INVITATION FOR BIDS
for
MALUHIA
REPALCE EXIT DOORS
1027 Hala Drive
Honolulu, Oahu, Hawaii

FY 23M-0121

ADDENDUM NO. 1

MARCH 20, 2024

SHEET TITLE TITLE SHEET, CONSULTANTS, INDEX TO DRAWINGS, LOCATION MAP, VICINITY MAP, GENERAL NOTES & PROJECT NOTES

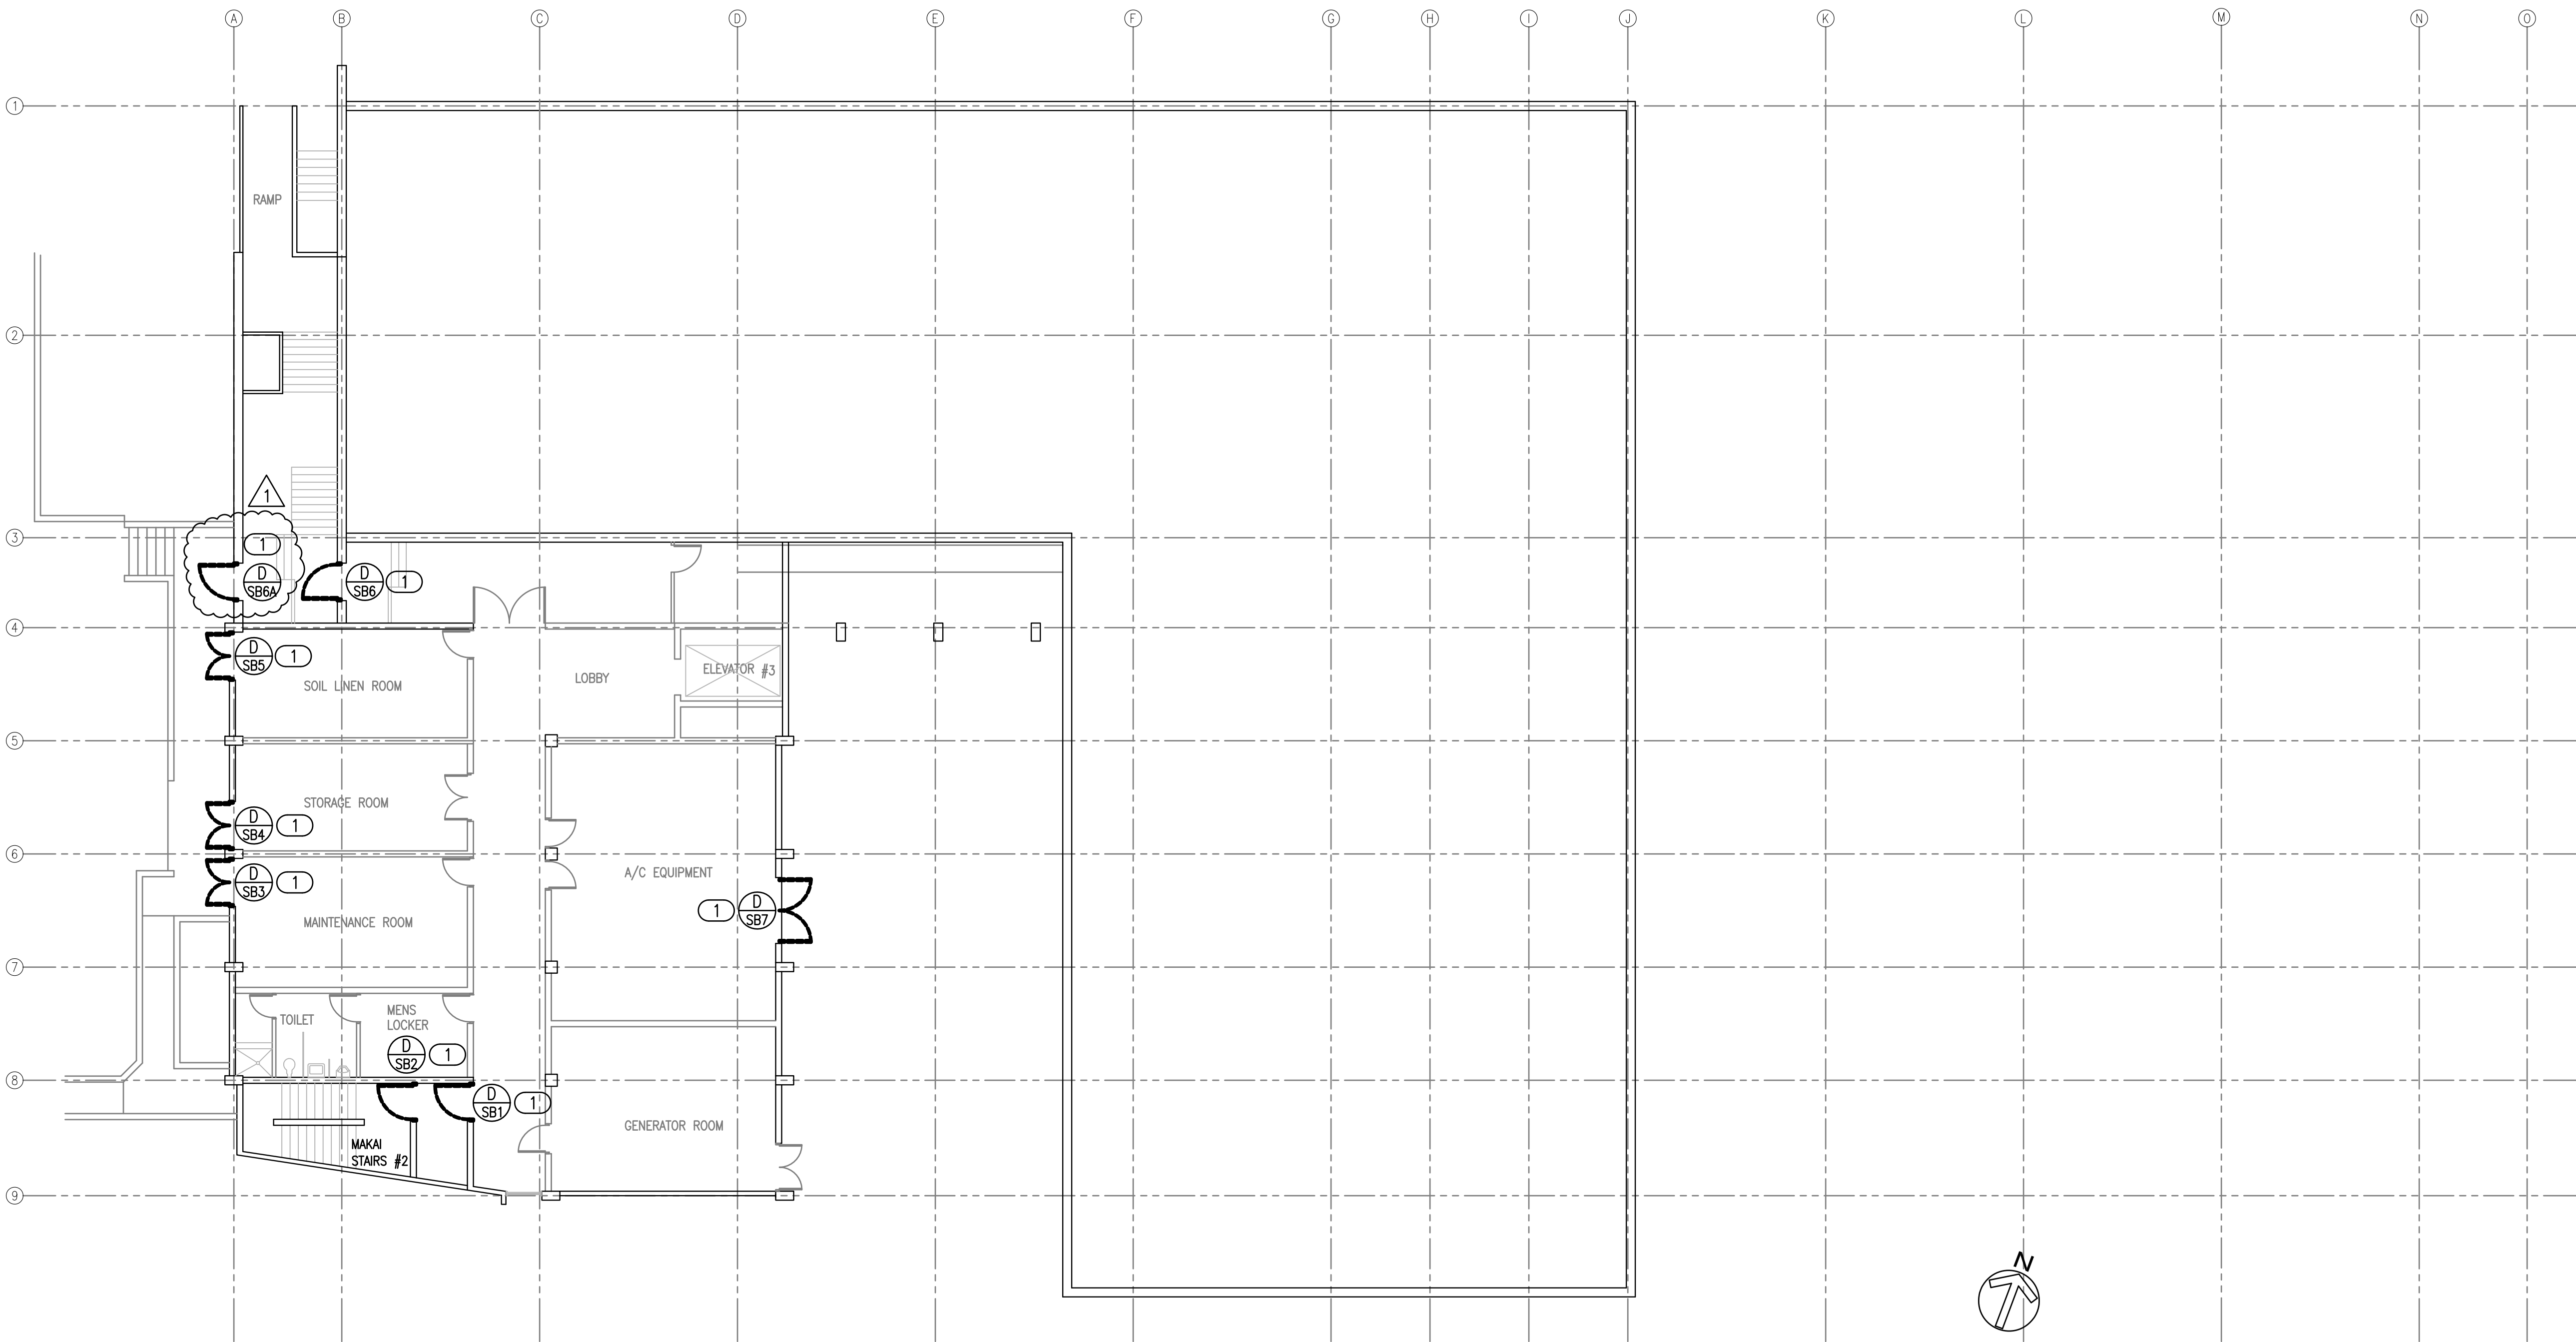
1. Sht. T-1.0 – Revise NOTES to add SPECIAL PROVISIONS, and SCHEDULE FOR DOOR REPLACEMENT. See attached Sht. T-1.1, delta 1, dated 3/20/24.
2. Sht. A-2.0 – Revise Sub-Basement Plan – Demo Work to add D/SB6A. See attached Sht. A-2.0, delta 1, dated 3/20/24.
3. Sht. A-2.1 – Revise Basement Plan – Demo Work to add D/B7. See attached Sht. A-2.1, delta 1, dated 3/20/24.
4. Sht. A-3.0 – Revise Sub-Basement Plan – New Work to add D/SB6A. See attached Sht. A-3.0, delta 1, dated 3/20/24.
5. Sht. A-3.1 – Revise Basement Plan – New Work to add D/B7. See attached Sht. A-3.1, delta 1, dated 3/20/24.

SPECIAL PROVISIONS:

SCHEDULE FOR DOOR REPLACEMENT:

DOOR SCHEDULE, DOOR TYPE & DETAILS

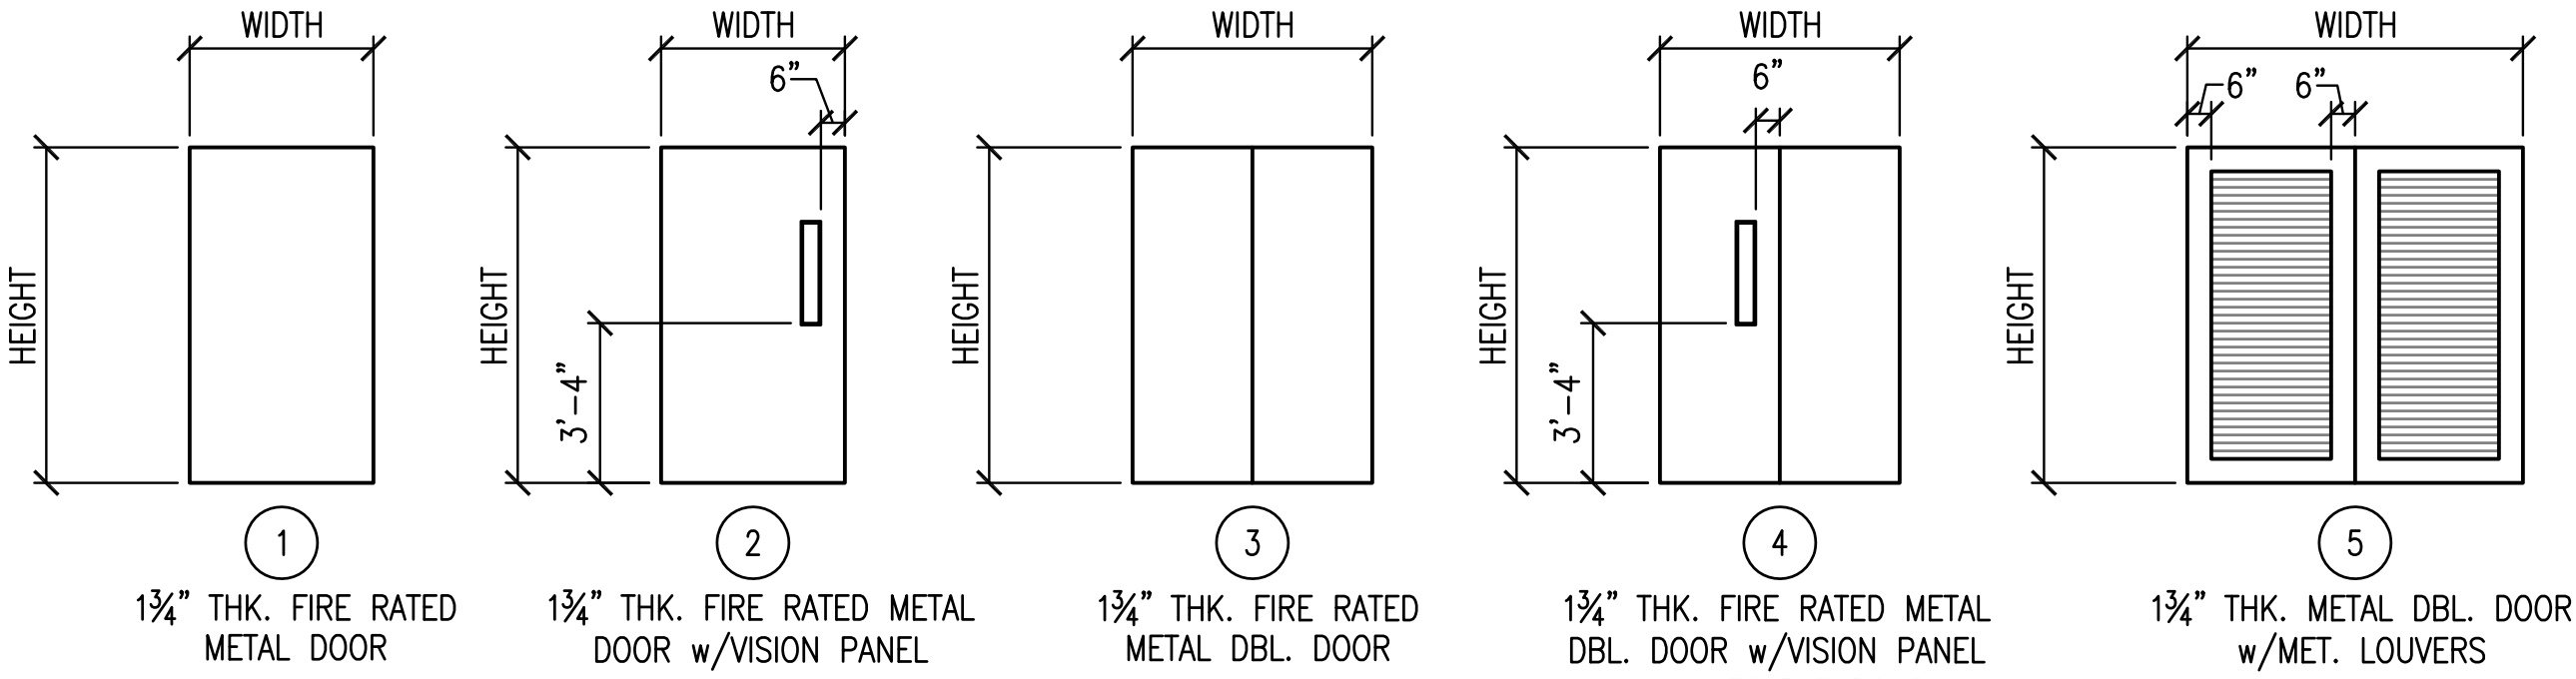
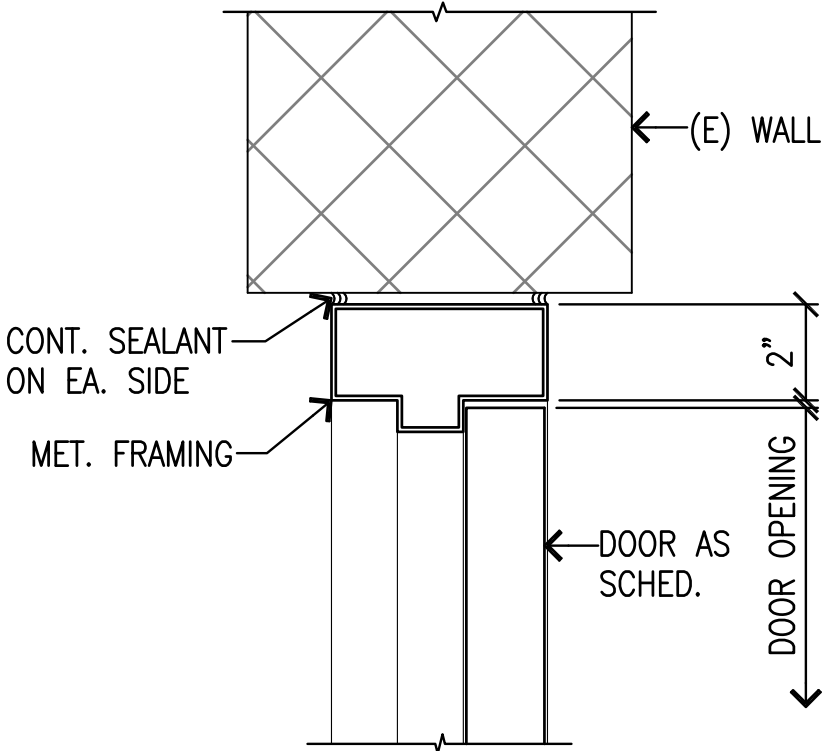
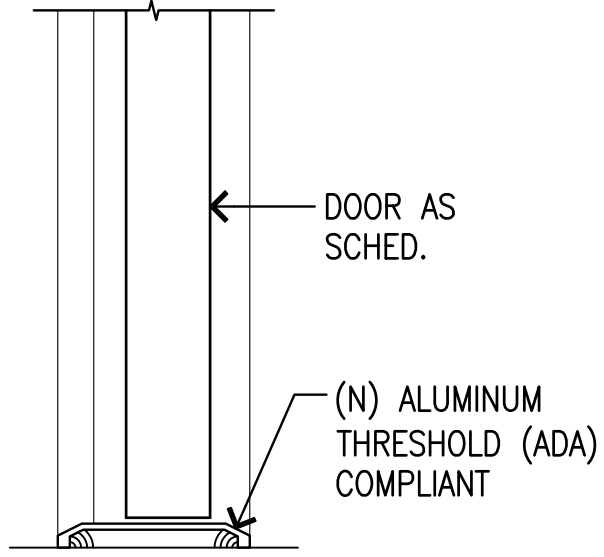
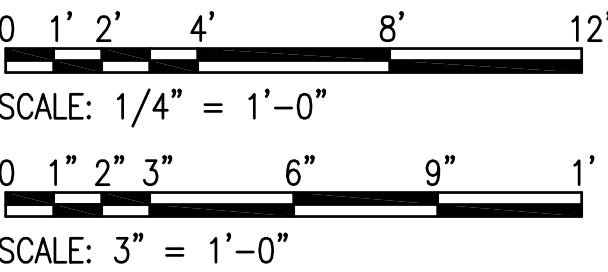
6. Sht. A-4.0 – Revise Door Schedule. See attached Sht. 4.0, delta 1, dated 3/20/24.
